**ADDENDUM # 1**

**Title: RIC- Fogarty – Renovations to Laboratory 242**

**DOCUMENT 00900 - ADDENDA AND MODIFICATIONS**

**ADDENDUM NO. 1 – June 7, 2012**

SKE-1

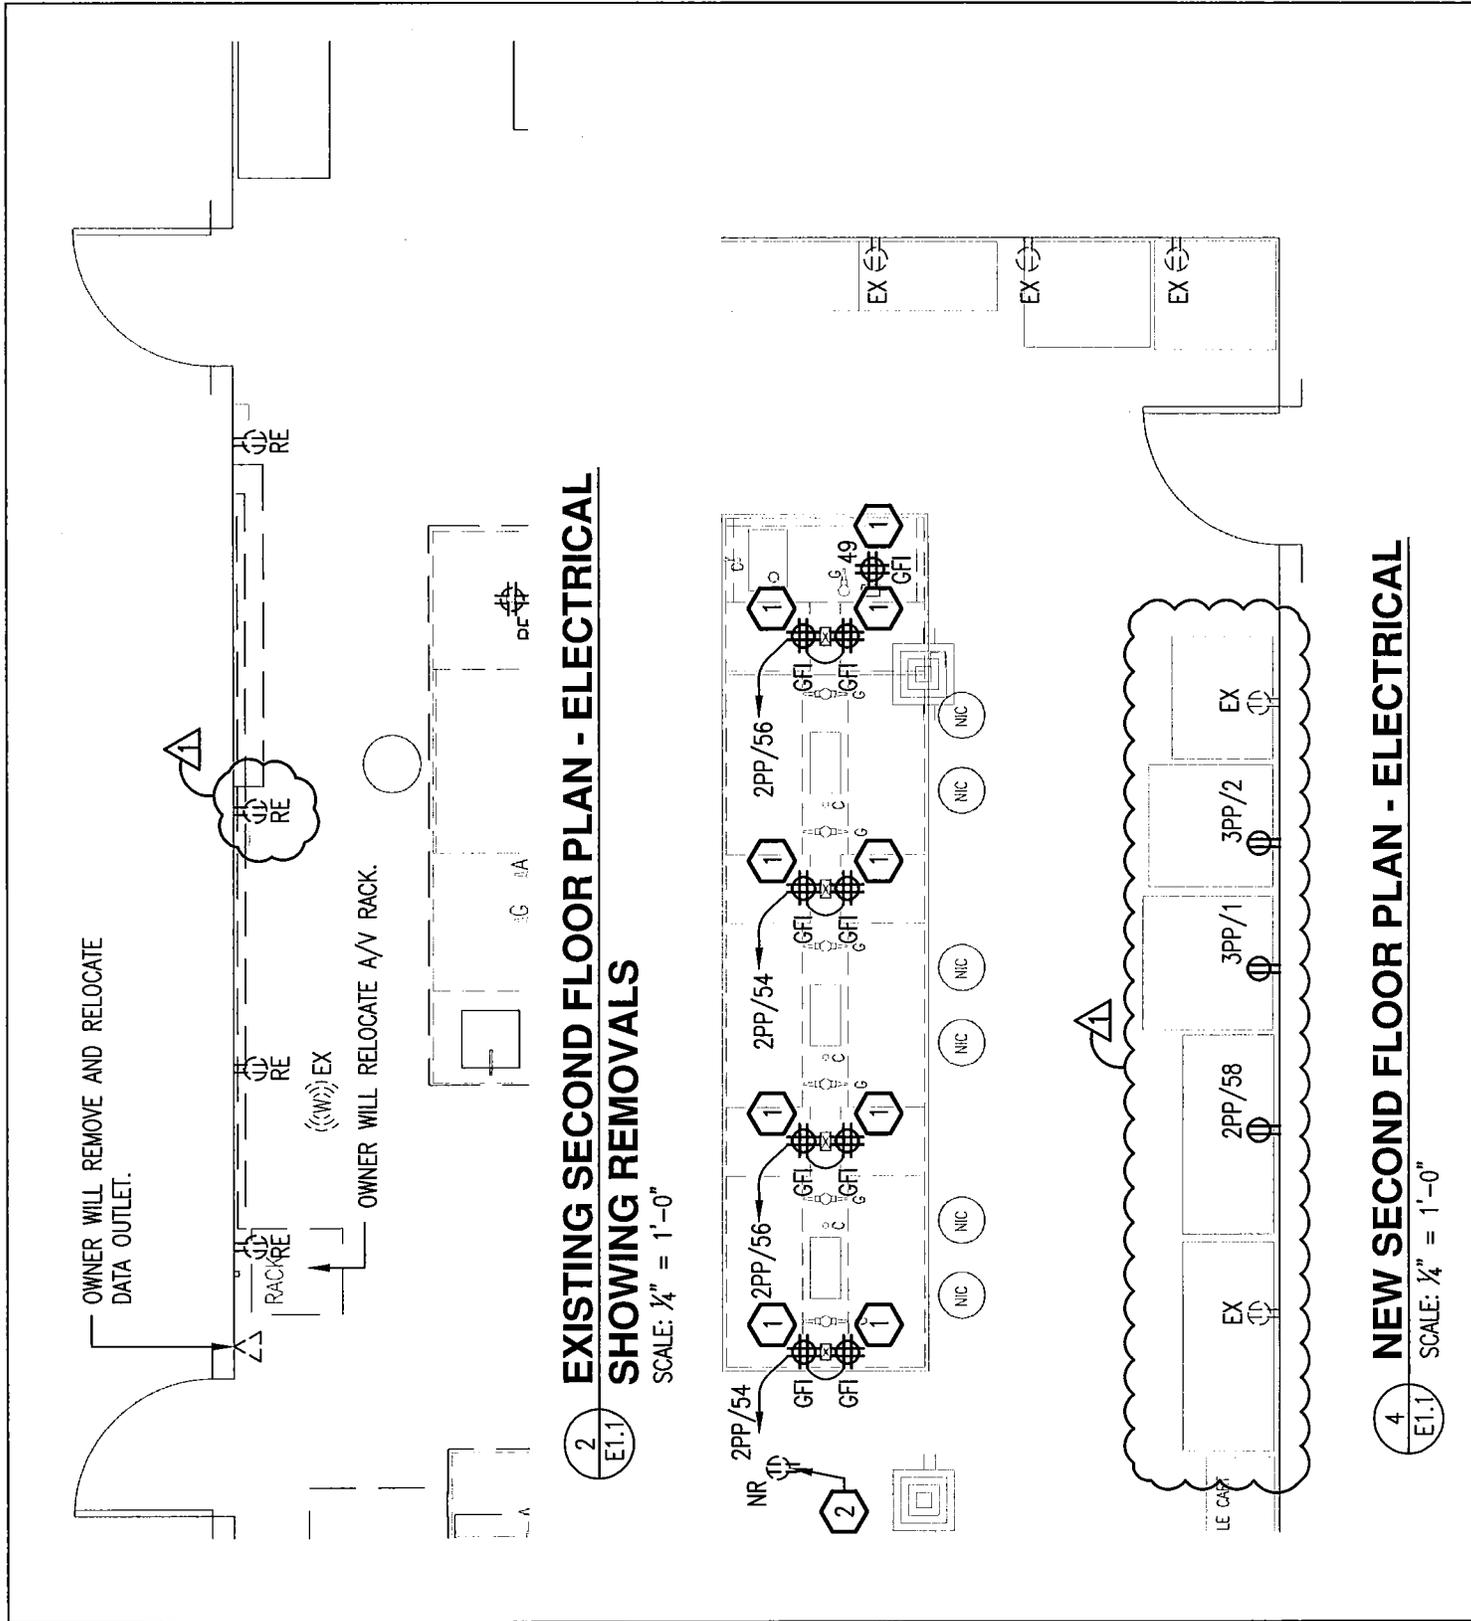
**DRAWING E1.1 – EXISTING AND NEW FLOOR PLANS- ELECTRICAL**

14. Refer to revisions shown on SKE-1, drawing attached.
